BULLETIN NO: 08 - 80

SUBJECT: CR-2020

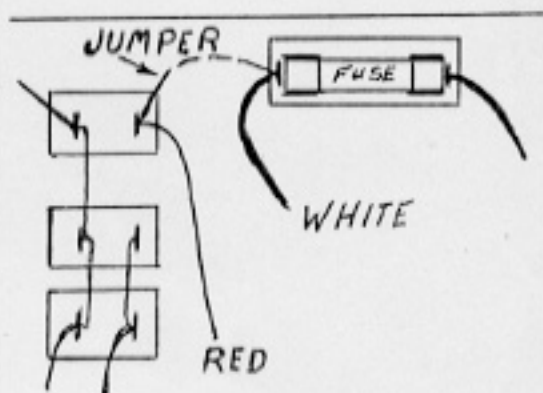
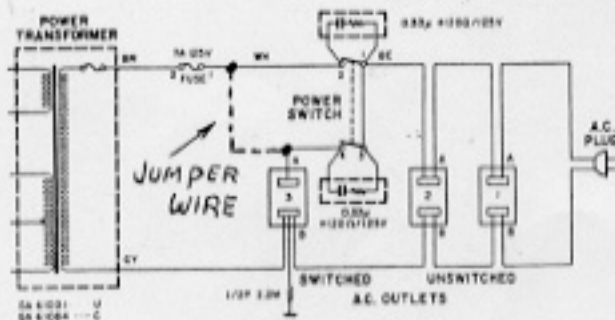
Problem: Power switch failure.

Cause: Pitting and burning of switch contact due to high current spike when set is switched off. (Back E.M.F. from power transformer).

Remedy: Replace power on/off switch (KA200630).
Install a jumper wire between the fuse holder (white wire) and the switched AC outlet (red wire).

Install the jumper wire on all units received for service that have not been modified.
